UNITED STATES PATENT AND TRADEMARK OFFICE

APPLICATION NO.	FILING DATE	FIRST NAMED INVENTOR	ATTORNEY DOCKET NO.	CONFIRMATION NO.
10/700,533	11/05/2003	Gyora Mihaly Pal Benedek	3069/1	6033
7590	05/19/2004			EXAMINER CEGIELNIK, URSZULA M
DR. MARK FRIEDMAN LTD. C/o Bill Polkinghorn Discovery Dispatch 9003 Florin Way Upper Marlboro, MD 20772			ART UNIT 3712	PAPER NUMBER
DATE MAILED: 05/19/2004

Office Action Summary	Application No.	Applicant(s)	
	10/700,533	BENEDEK ET AL.	
	Examiner	Art Unit	
	Urszula M Cegielnik	3712

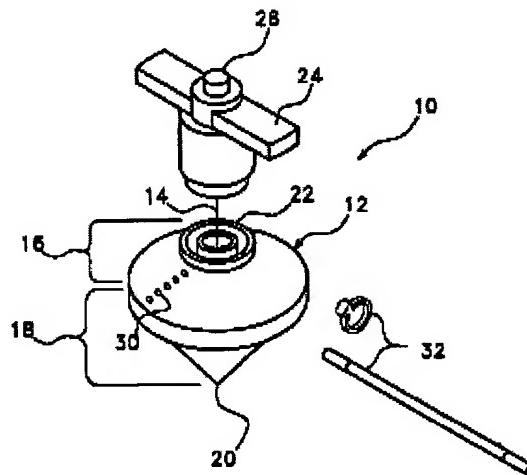
Claims 1-9, 16, 17, 22, 23, 24, 29, and 30 are rejected under 35 U.S.C. 102(b) as being anticipated by Nelson.

Nelson discloses a rotating device comprising a rotatable body (12); inside said rotatable body (12), a rotation data measuring means (46); a control unit (42) said control unit (42) configured to receive data relating to rotation of said body (12) from

said rotation data measuring means (46) (col. 4, lines 39-47); said body is in the form of a top; all components of said rotation data measuring means (46) are associated with said rotatable body (12); a wireless data receiver; said receiver configured to receive data from a remote location and pass said data to said control unit (col. 3, lines 19-26); the rotation data measuring means (46) are configured to produce a substantially sinusoidal output signal having a frequency related to rotation of the body (the rotation means, i.e., the induction coil 46 is inherently capable of producing a sinusoidal output signal); the rotation data measuring means (46) comprises a means for detecting (the earth's) magnetic field (the rotation data measuring means is an induction coil, it is inherently capable of detecting the earth's magnetic field); the rotation data measuring means comprises an induction coil (46).

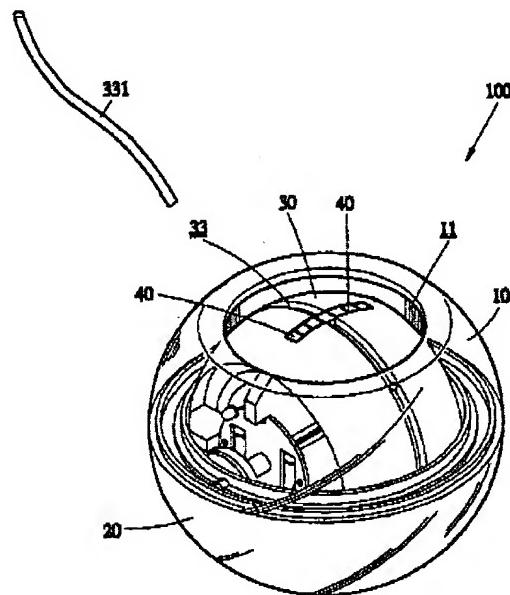
Claims 1, 3, and 4 are rejected under 35 U.S.C. 102(e) as being anticipated by Chuang et al.

Chuang et al. disclose a rotating device comprising a rotatable body (10,20); inside said rotatable body (10,20), a rotation data measuring means (70); a control unit (60); said control unit (60) configured to receive data relating to rotation of said body (10,20) from said rotation data measuring means (70); said body is in the form of a ball; all components of said rotation data measuring means (70) are associated with said rotatable body (10,20) (col. 4, lines 18-26); the display mechanism (11) comprises a plurality of independently activable and deactivable light sources (40) (col. 1, lines 54-60); the control unit is configured to calculate a number of revolutions that the rotatable body has performed and display the number of revolutions using the display mechanism (col. 34, lines 40-43 and col. 18-20); the control unit (60) is configured to calculate a rate of rotation of the rotatable body (10,20) and display the rate of rotation using the display mechanism (11) (col. 5, lines 16-19).
